EIGHTEEN SUNSET

1733-1759 PURDY AVENUE & 1724-1752 BAY ROAD
MIAMI BEACH, FLORIDA
DESIGN REVIEW BOARD
FINAL SUBMITTAL MAY 18, 2020

DESIGN REVIEW BOARD *PROPOSED*

NEW MIXED-USE RETAIL-RESIDENTIAL DEVELOPMENT

SITE PLAN PROPOSED

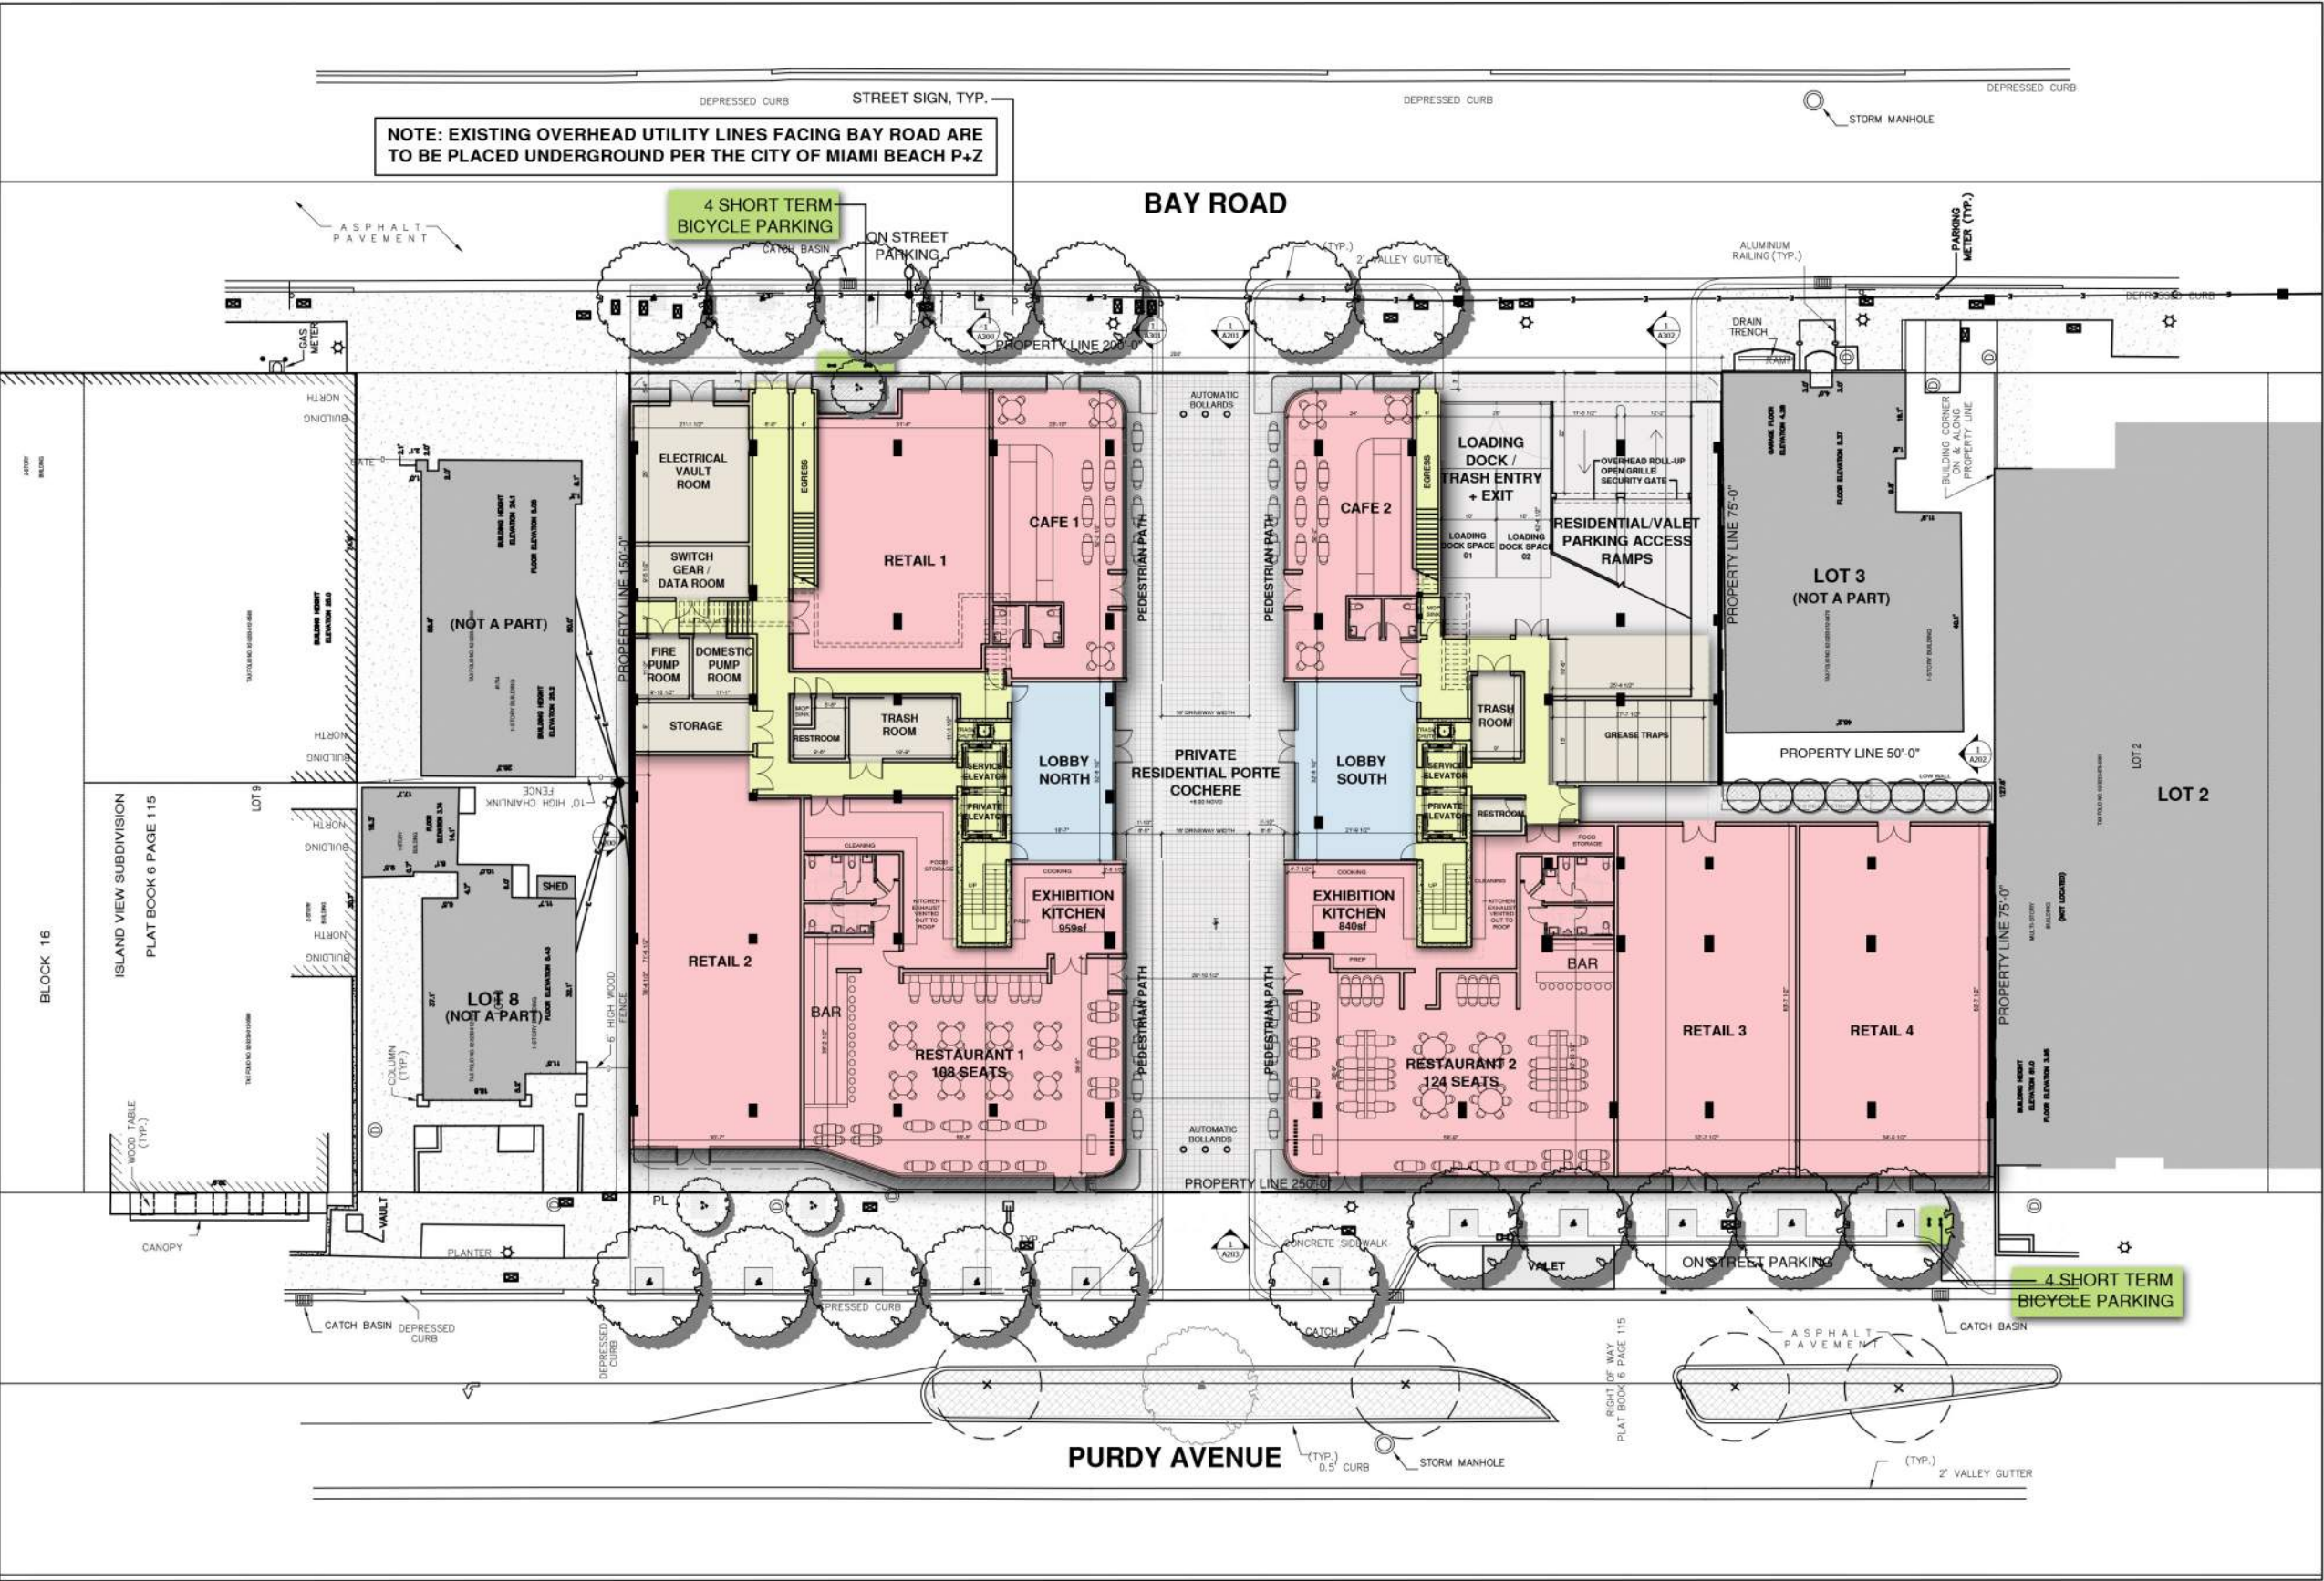
NOTE A:
CHANGES TO BE APPROVED ADMINISTRATIVELY. NOT PART OF THIS APPLICATION.

A) GLAZING PUSHED BACK 8'-0" FROM BAY RD.

B) LOCATION OF GARAGE RAMP AND LOADING DOCK FLIPPED.

C) GLAZING PUSHED BACK 10'-0" FROM PURDY RD.

D) RELOCATION OF STAIR AND ELEVATOR CORES.

F) ROOF POOL RELOCATED.

UPPER FLOOR PLANS *PROPOSED*

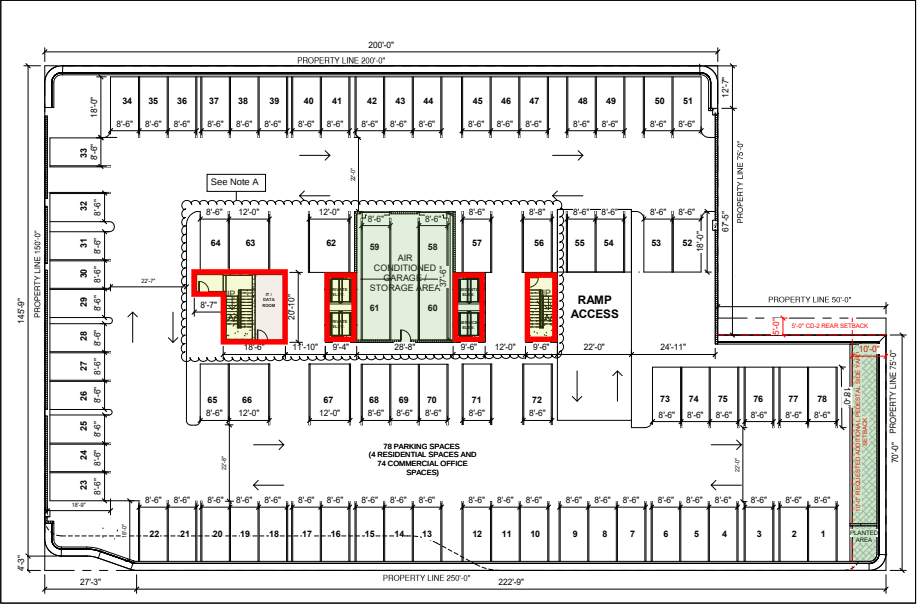
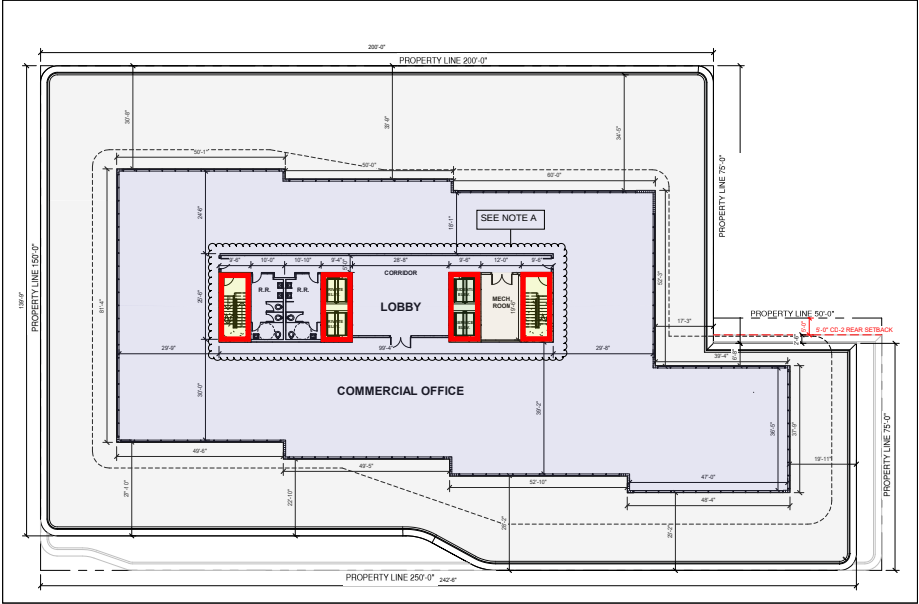
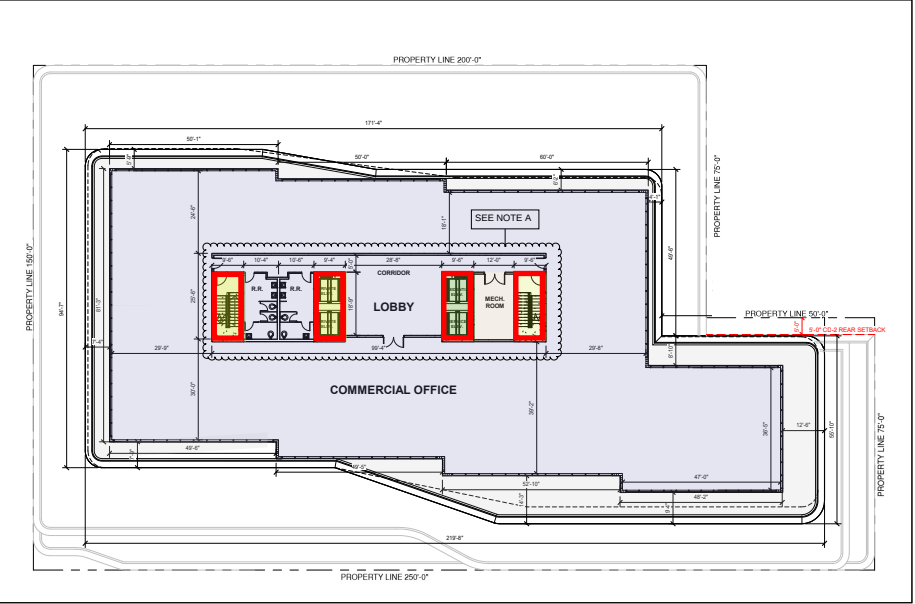
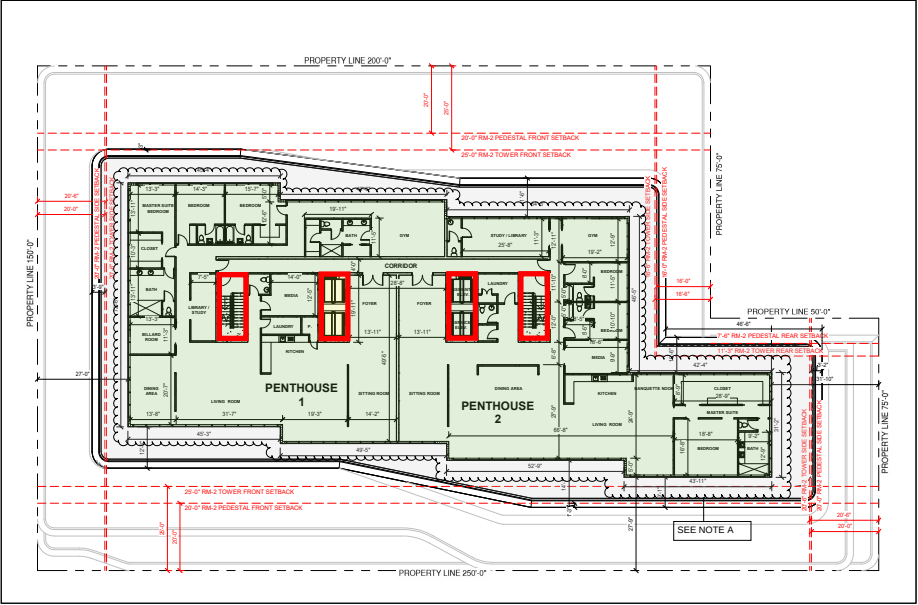
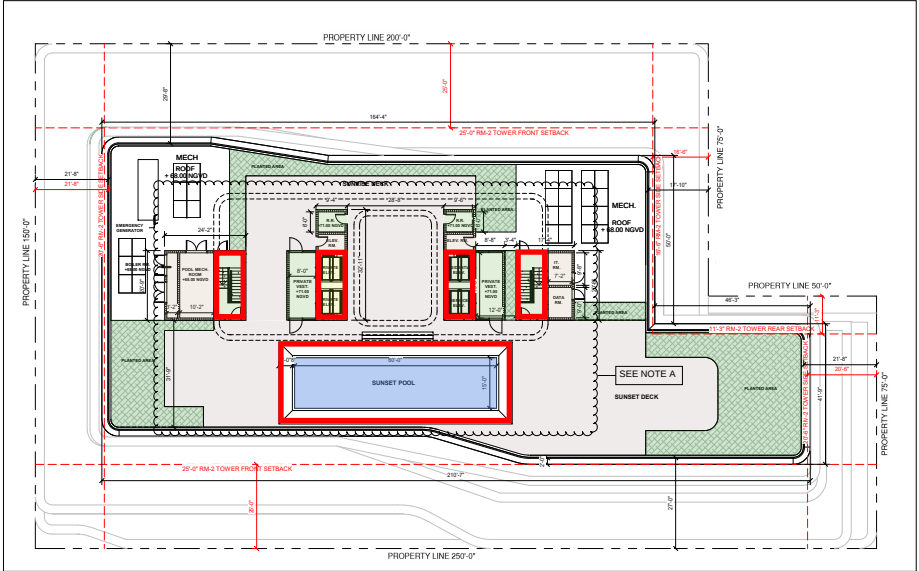
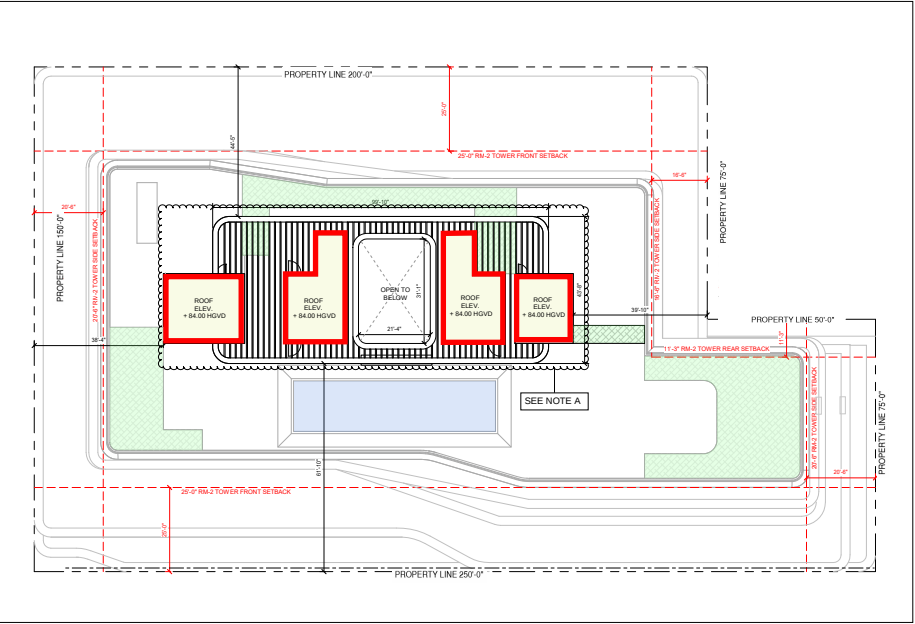
NOTE A:
CHANGES TO BE APPROVED ADMINISTRATIVELY. NOT PART OF THIS APPLICATION.

A) GLAZING PUSHED BACK 8'-0" FROM BAY RD.

B) LOCATION OF GARAGE RAMP AND LOADING DOCK FLIPPED

C) GLAZING PUSHED BACK 10'-0" FROM PURDY RD.

D) RELOCATION OF STAIR AND ELEVATOR CORES

F) ROOF POOL RELOCATED
